Our Ref: SJW\2018s1208-L-L001-4

16 October 2018

Wressle - New Application Review (Planning Reference PA/2018/1316)

TECHNICAL APPENDIX A

Box 1 – Reproduction of Envireau Water Figure 19

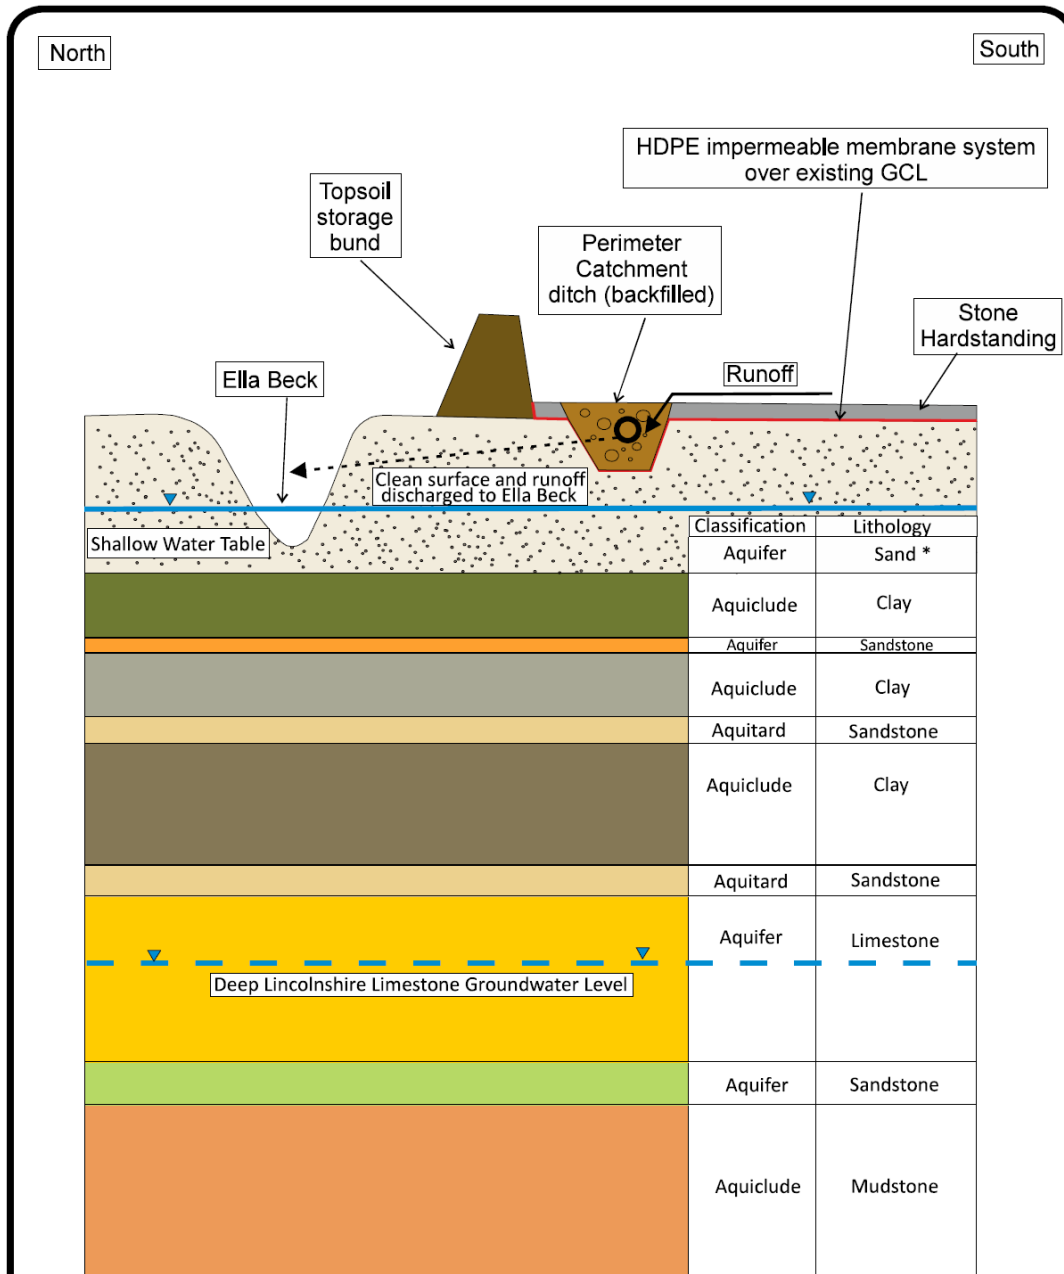
Envireau's Hydrogeological Conceptual Model of the well site is given in Figure 19 (see Box 1 below). This is an improvement on the conceptual model presented in the previous reports as it provides more detail on the near surface strata beneath the well site based upon new ground investigation data. However, we would disagree with a number of aspects of it.

1. The clay layer (layer 2) beneath the top sand layer is termed an aquiclude². The thickness of this layer is only approximately 1.4m from the geology logs. An aquiclude is very rare in geology and implies a completely impermeable horizon. The report indicates that this horizon (probably Kellaways Clays) is probably absent from the far west of the site, and so is not likely to provide a totally effective seal for the underlying horizons. A more reasonable term would be aquitard³ which implies a layer which limits groundwater flow but which over longer timescales may allow some leakage.

2. The 3rd layer from the top labelled Aquifer – Sandstone relates to the Cornbrash Formation which has a likely thickness of 0.9-1.3m on site. However, the relative thicknesses of these 2nd and 3rd layers in the conceptual model give the clay layer as over 5 times thicker than the sandstone layer 3. This is highly misleading.

5. It would have been useful to include all the observed water levels in the conceptual model figure including those in the Great Oolite.
6. There are no groundwater flow pathways indicated on site. A conceptual model should indicate groundwater pathways, recharge areas and discharges⁴.

9. Although conceptual models are often not to an exact scale, an approximate scale or proportion is usually indicated to aid understanding and to ensure the correct perspective. This has not been provided. The cross section in Figure 17 provides this and should have been used as the basis for the conceptual model as it has a more realistic relative thickness for the permeable and less permeable layers. Figure 19 Conceptual Model has much thicker clay layers relative to the sandstone layers. This provides an impression of an unduly low permeability representation of the sub-surface.

Overall, the limited correlation between the on-site borehole logs, nearby BGS logs and the conceptual model provided means there can be limited confidence in the conceptual model.

Box 2 - Reproduction of Envireau Water Figure 20

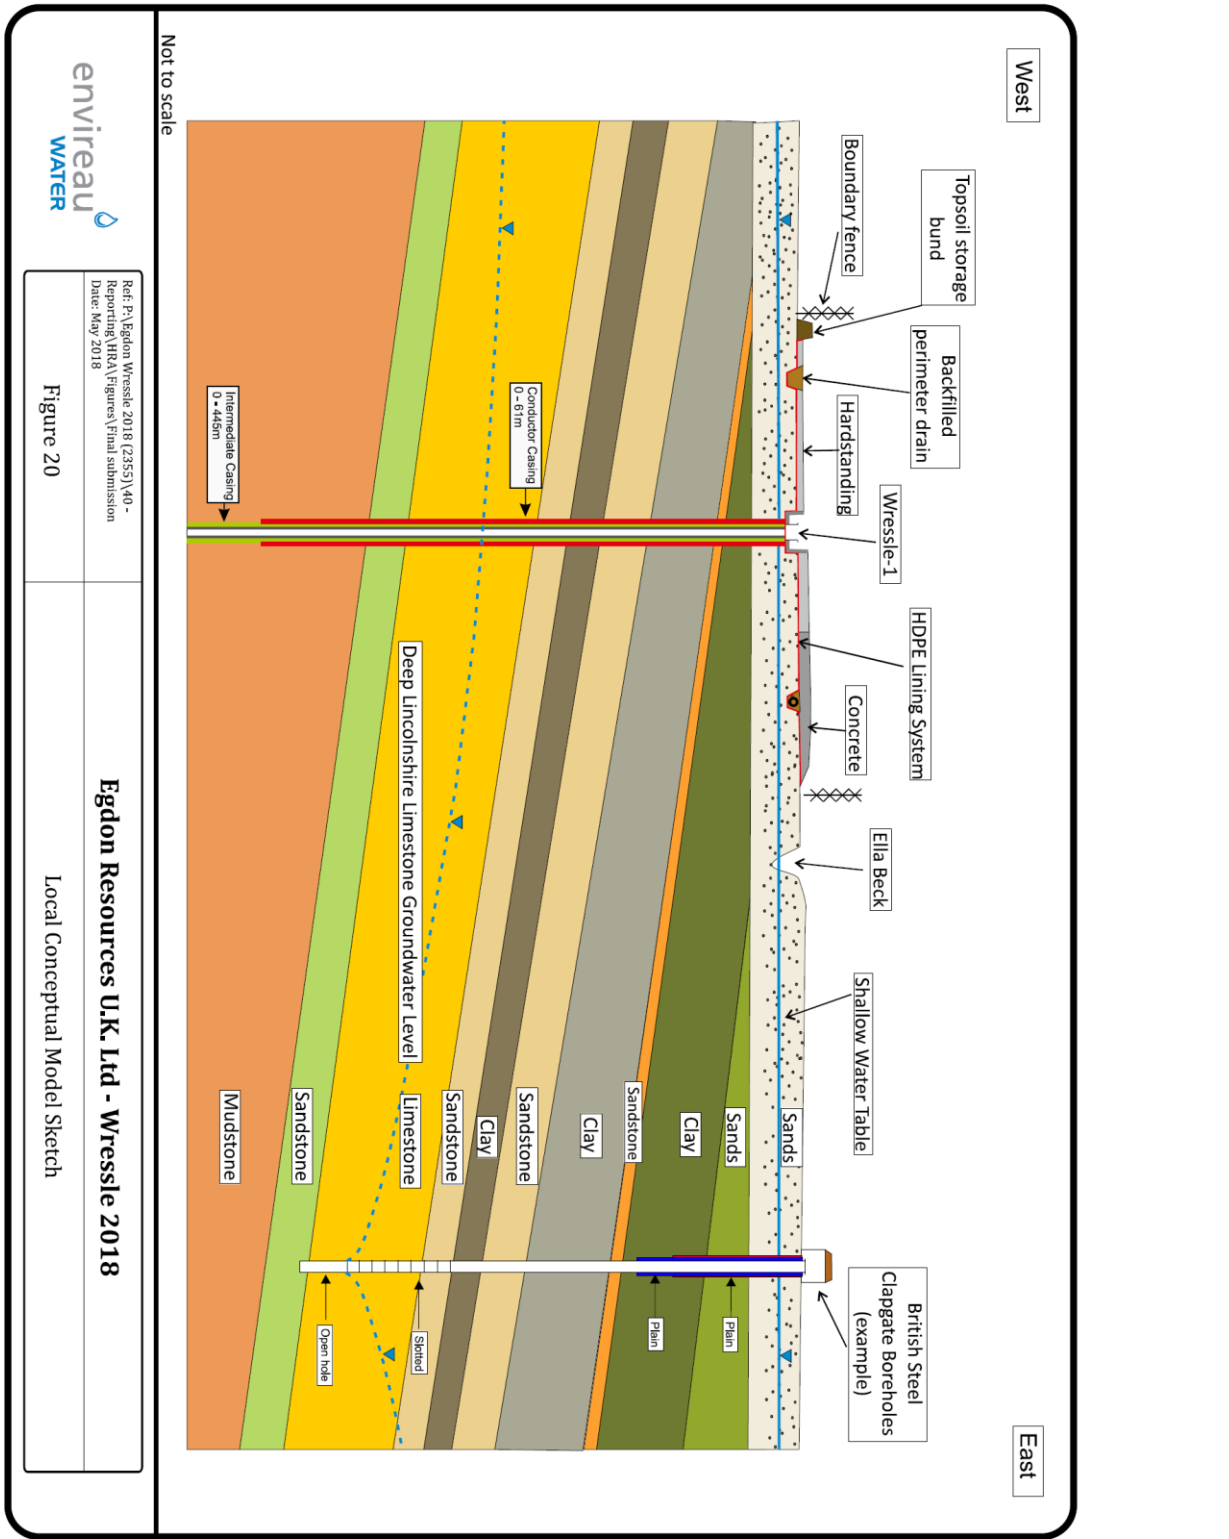
The Local Conceptual Model Sketch is given in Figure 20 (see Box 2 below). This duplicates the same geological layers as in Figure 19 and has the same problems with regard to the representation of the Blisworth Limestone/Clay/Rutland Formations. The more geologically accurate layers shown in Figure 17 would have been better.

An example of the Clapgate boreholes (British Steel supply) is given in Figure 20 which is only screened in the Lincolnshire Limestone. Previously Envireau provided screen details of the Clapgate boreholes (Inquiry documentation) which showed that the boreholes G1 and G5 were screened in the Great Oolite Group, with G5 screened to just above the top of the Great Oolite, i.e. screened throughout the Cornbrash Formation. Details given elsewhere in the report (Table 21 page 39) indicate that G1 is 400m from the site and G5 is 1.9km from the site. This means that there is hydraulic connection between the site and the Clapgate Boreholes which has not been shown in Figure 20. [See JBA Appendix C Interpretative Geological Cross Section enclosed and Envireau Figure 4 British Steel as built construction enclosed.]

Whilst the requirement for a revised conceptual model was not included in the Inspector's decision considerable discussion was had at the inquiry regarding conceptual models. It is very important that the conceptual model is robust as the assessment of the risk of groundwater/surface water contamination depends upon the accuracy of the conceptual model and associated pathways between sources and receptors. The inaccuracies and omissions within the current conceptual model could lead to the omission of the pathway from the site, through the Cornbrash Formation to the British Steel Clapgate boreholes. It is essential that this pathway is considered fully in the risk assessment.
